ADDENDUM NO. 1 TO ALL BIDDERS:

Reference – Invitation for Bid:	IFB #015-0-2025/SNB Yates Elementary School Security Vestibule and Office Addition & Alterations
For Delivery To:	Newport News Public Schools
Bids Due:	March 27, 2025 at 2:00 PM EST

## ADDENDUM NO. 1

#### Yates Elementary School Security Vestibule and Office Addition & Alterations

A6.01

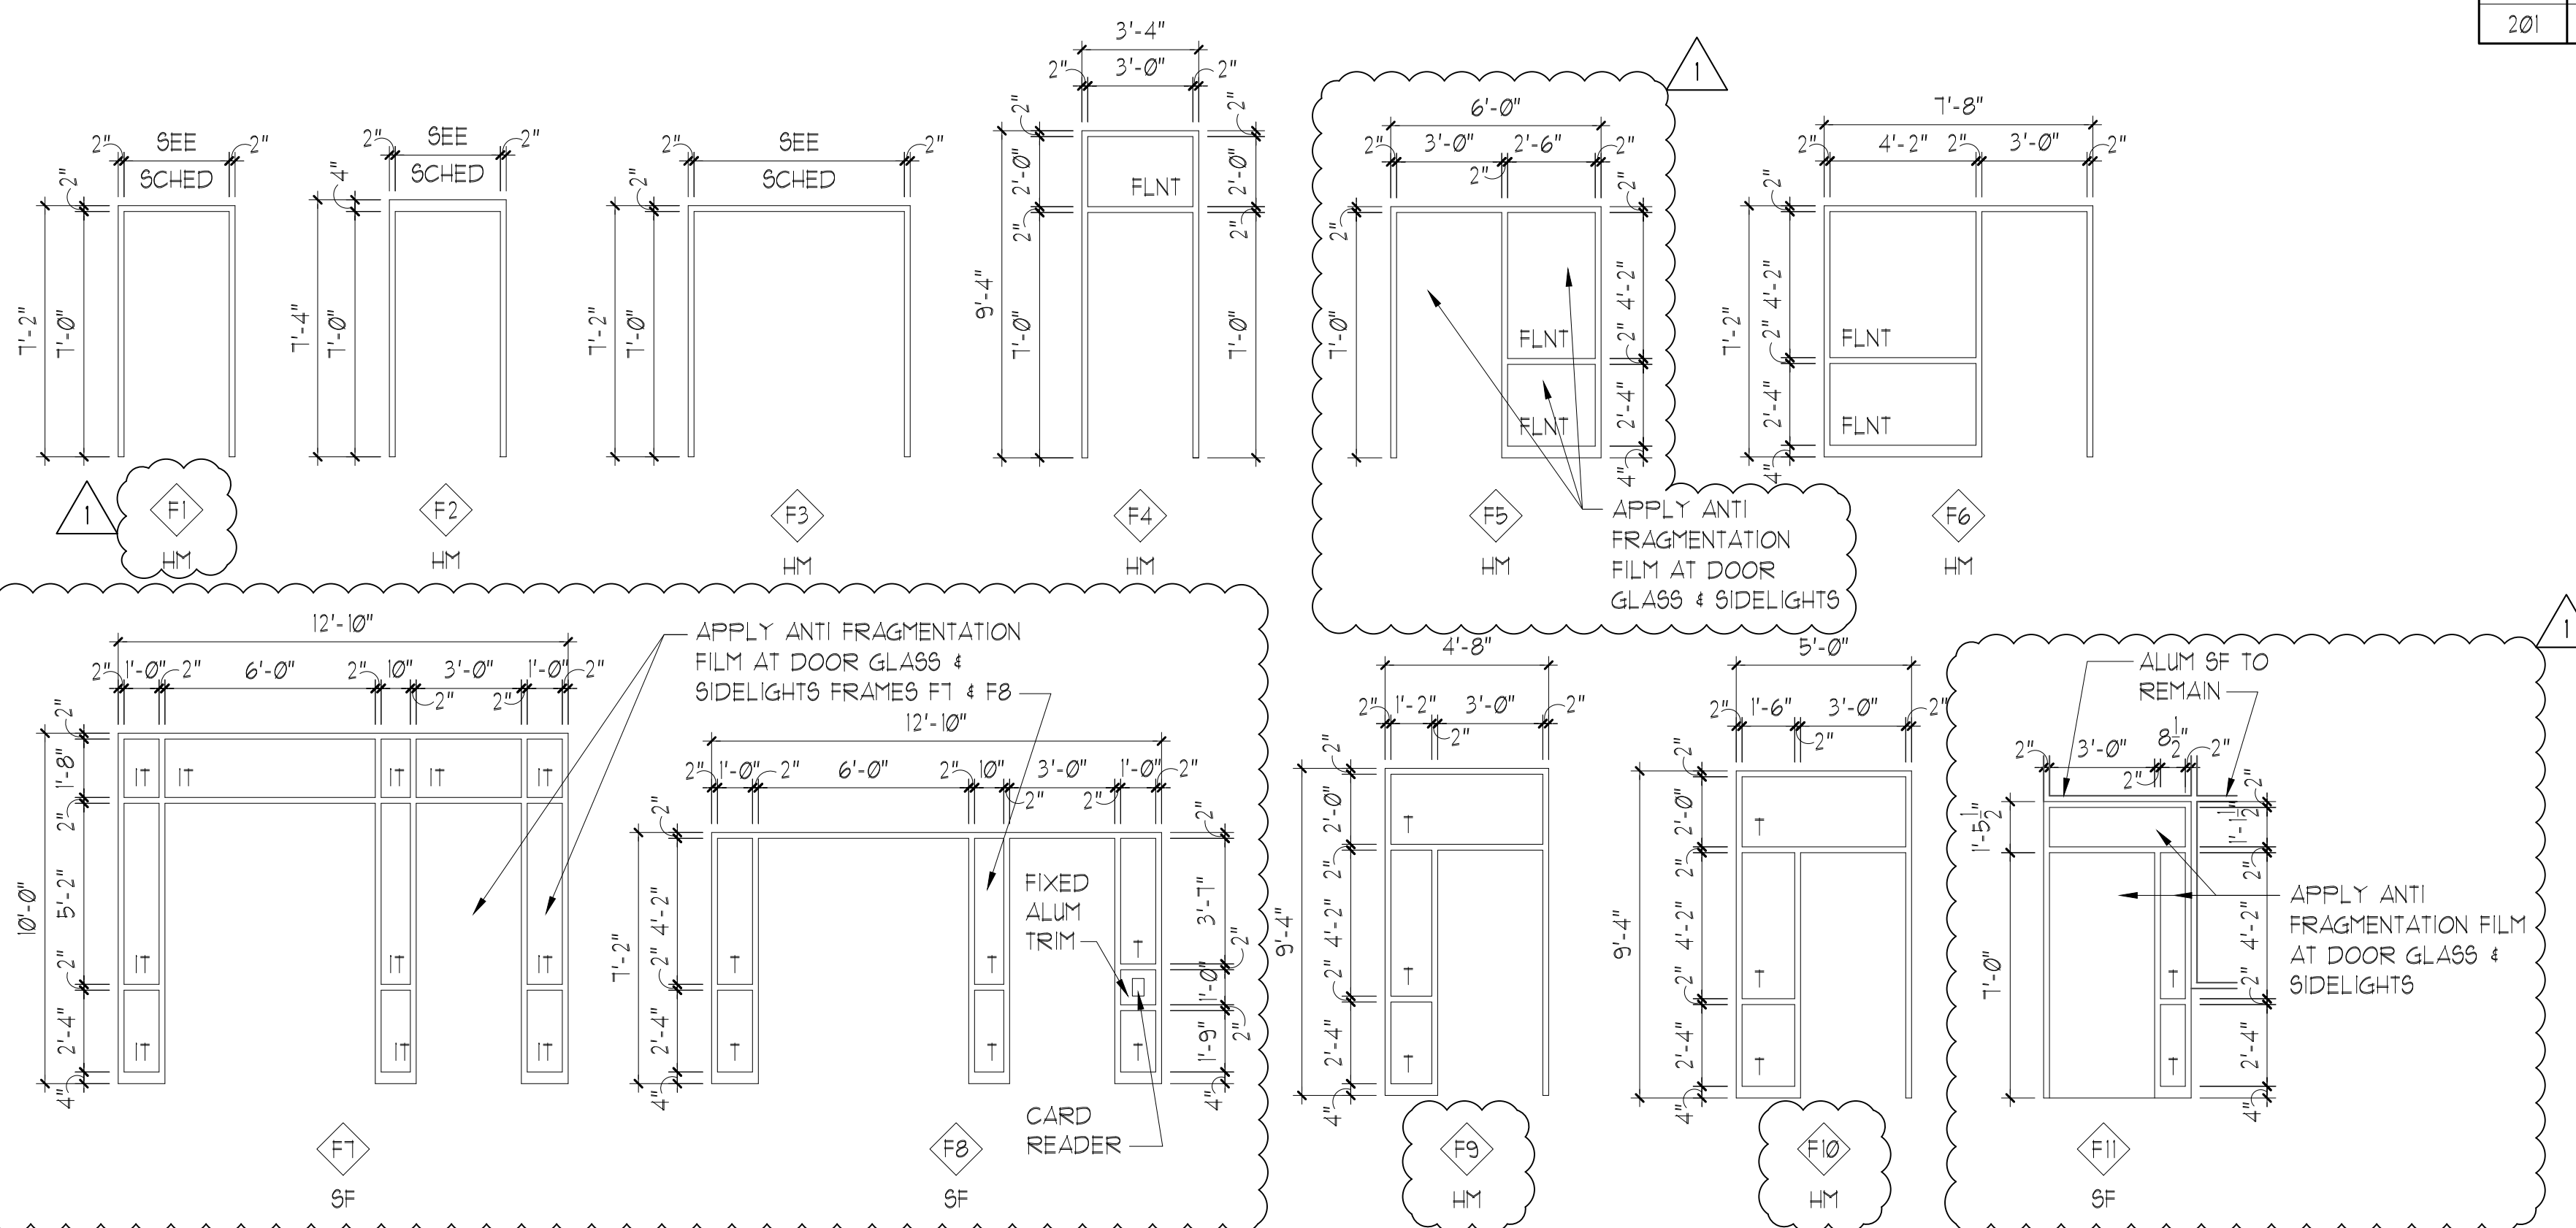
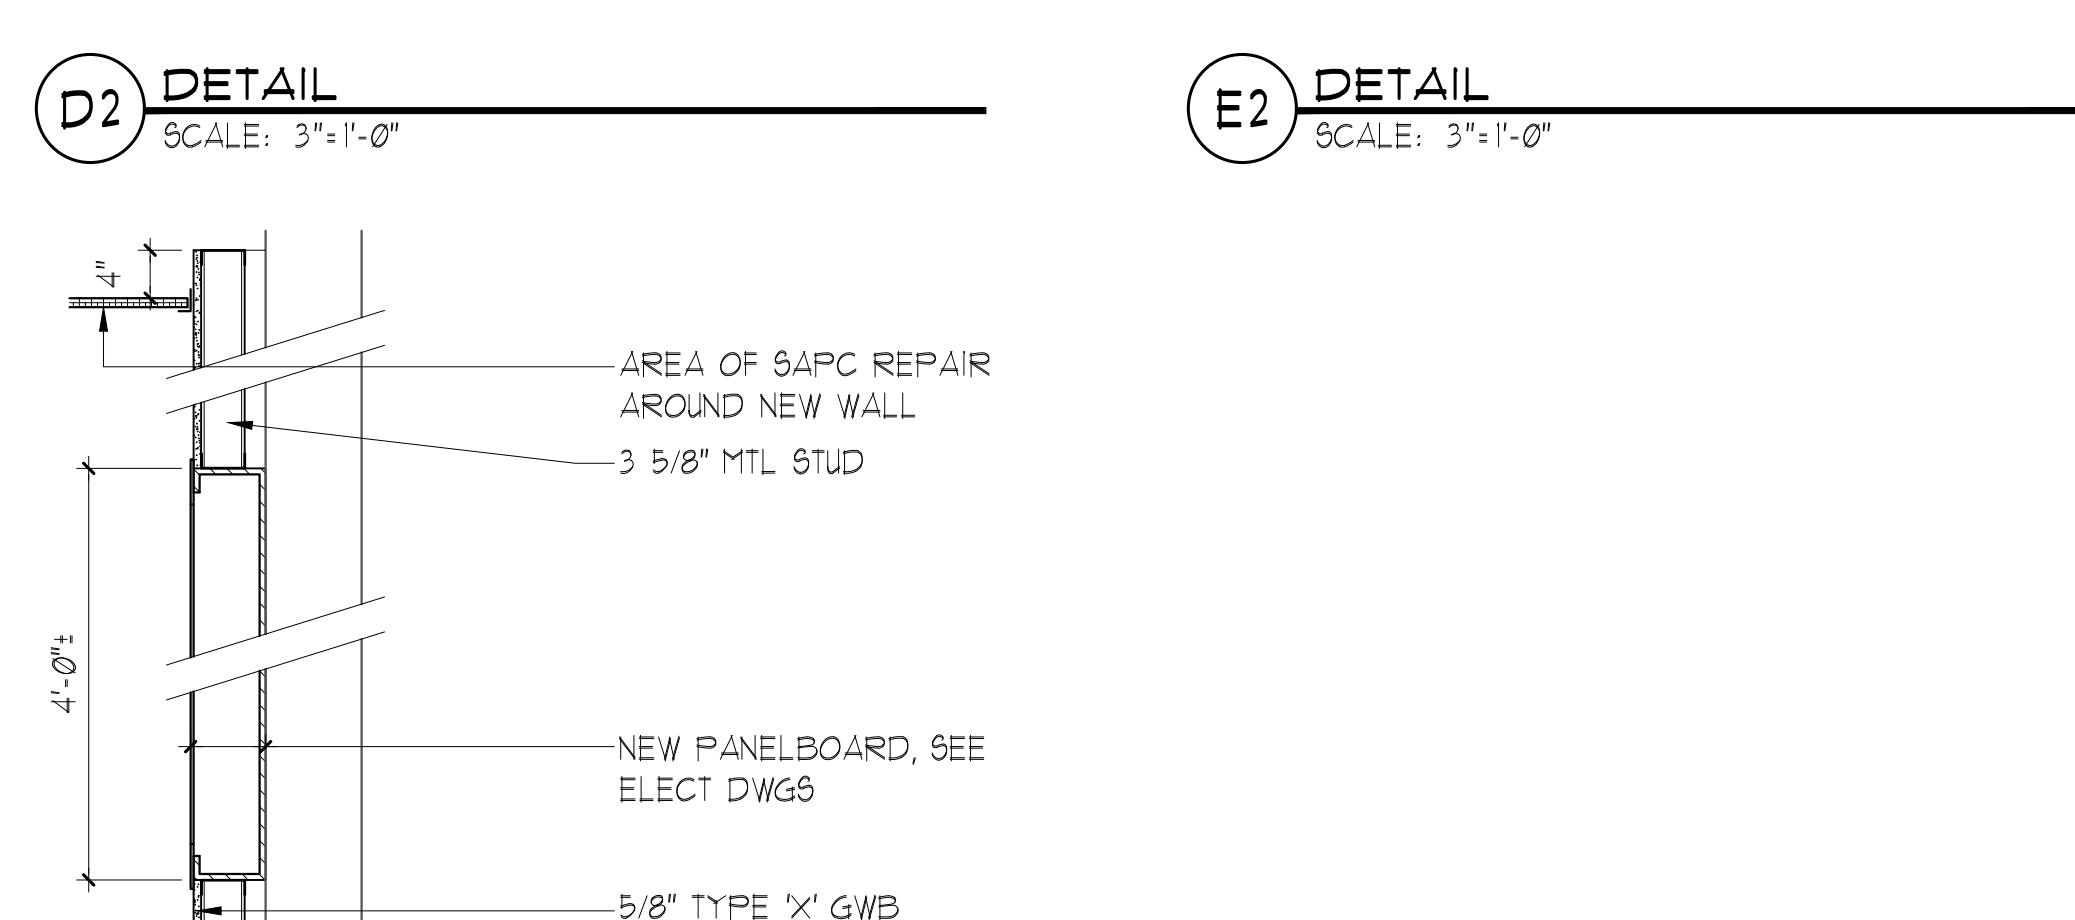
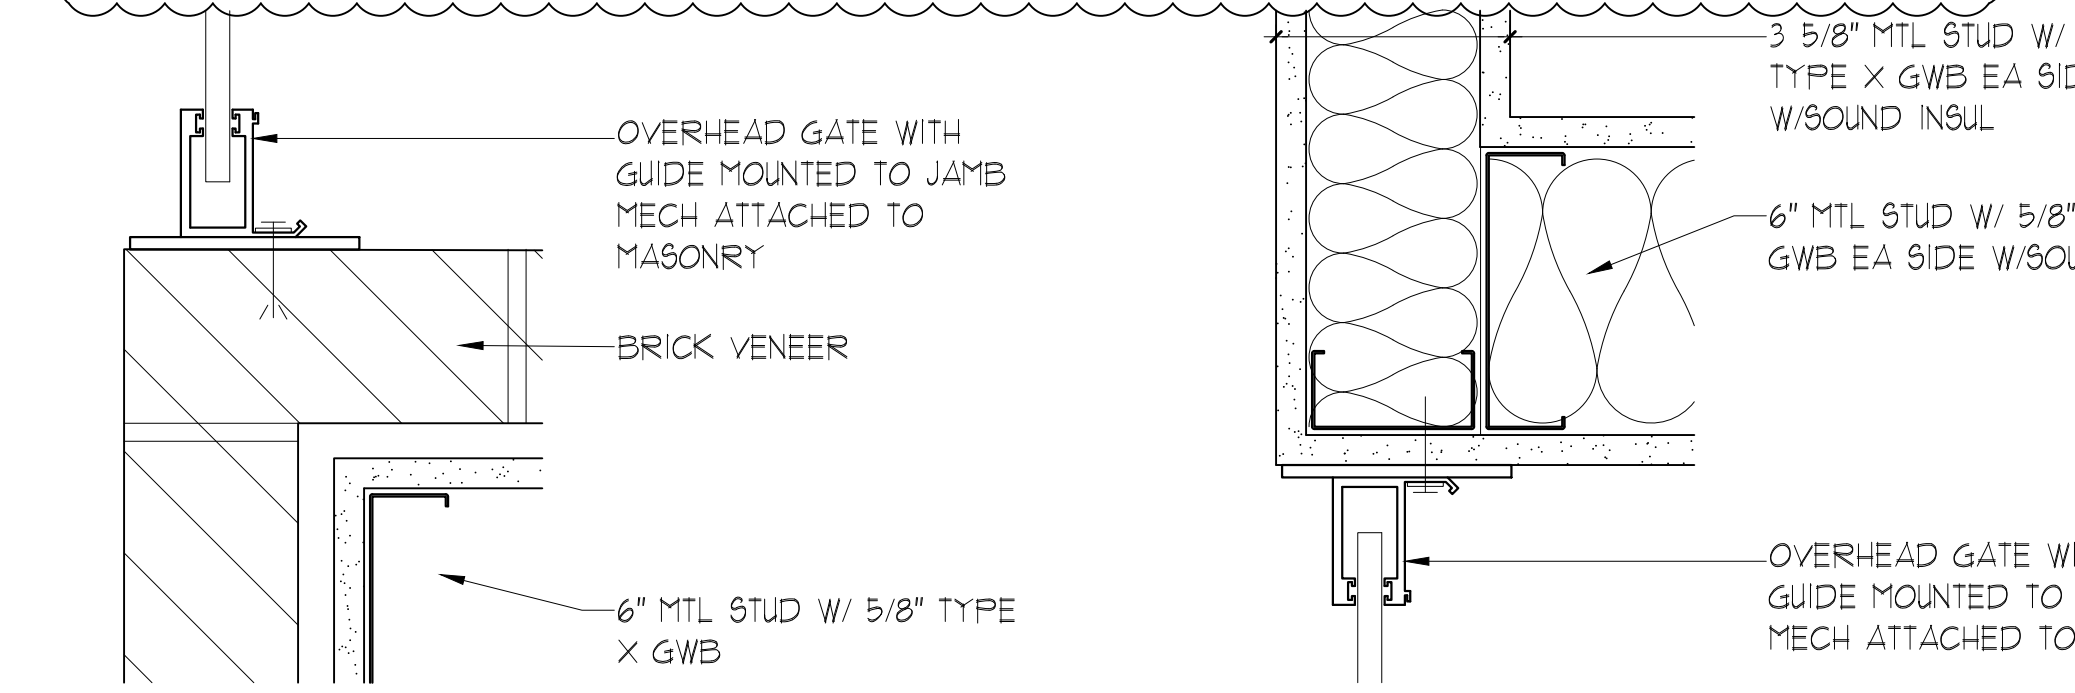
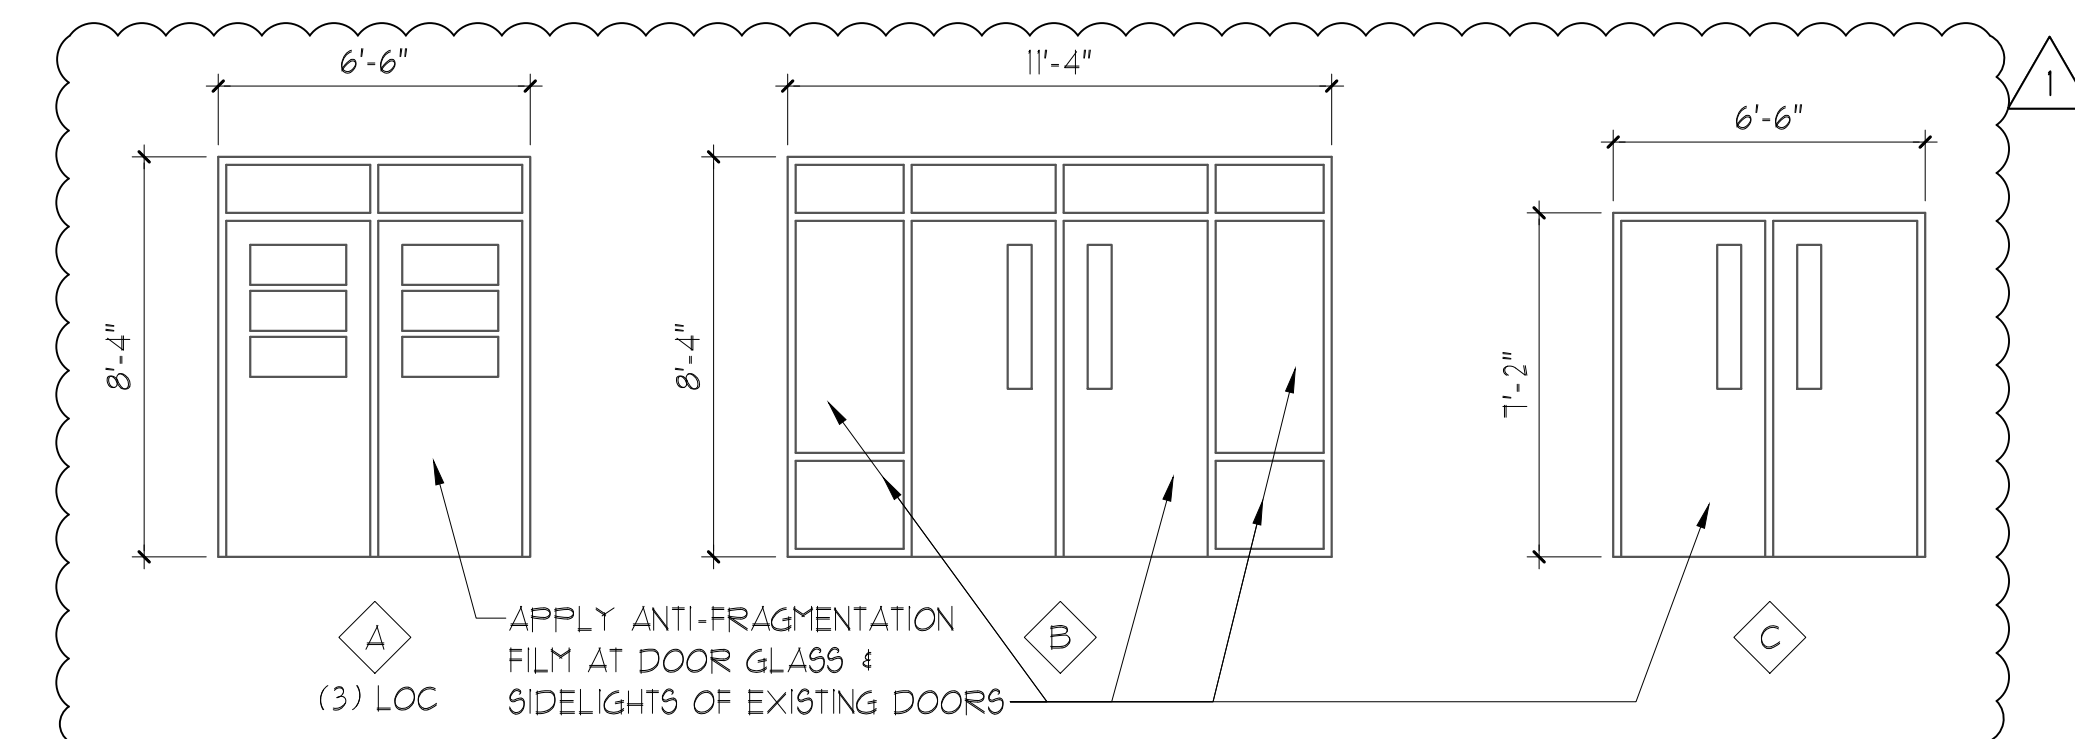
10. Architectural Drawing A6.01: This drawing has been revised as follows:
  - a) Door and Frame Schedule:
    - 1) Door 104B has been revised to a Solid-Core Wood (SCW) door in a Hollow Metal (HM).

- 2) Doors No. 104A, 104B and 111: These doors have been updated to include a 20-minute fire-resistance rating at each location.
  - b) Frame Elevations:

- 1) Door and Sidelight Frame Elevations F1, F9 and F10 have been revised to indicate Hollow Metal (HM) designations (as shown in the Door and Frame Schedule) in lieu of (aluminum) Storefront (SF) designations.

- 2) Door and Sidelight Frame Elevations F5, F7 and F8 have been revised to indicate application of Anti-Fragmentation Film to glass door inserts and sidelight glazing, as specified under Spec Section 088723.

- 3) ADD Window Frame Elevations 'A', 'B,' and 'C' to this sheet. These elevations indicate layout of existing doors and frames designated to receive application of Anti-Fragmentation Film to glass door inserts and sidelight

glazing, as specified under Spec Section 088723.

14. QUESTION: Frame Type F1 is called out as Storefront on the Door Frame Types but on the door schedule doors #105 and 106 are hollow metal doors calling for F1.

RESPONSE: Frame Type F1 should be hollow metal, intended installation in a GWB partition, and has been amended thus.
15. QUESTION: Frame Type F5 is called out as Hollow metal on the Door Frame Types but on the door schedule door #104B is storefront calling for F5.

RESPONSE: Door #104B shall be a SCW in a hollow metal frame (F5), not aluminum. It has been amended thus.
16. QUESTION: What does "X" denote on the door schedule? for example Doors # 119A, 119B, 120A, and 120B all call for XF1 which is not in the Door Frame Types. Does it denote existing?

RESPONSE: Yes, 'X' in this instance mans existing.
17. QUESTION: In addition, doors #102 and #103 are hollow metal doors calling for storefront frames.

RESPONSE: Doors #102 and #103 shall be SCW door type in HM frames, and are amended thus.
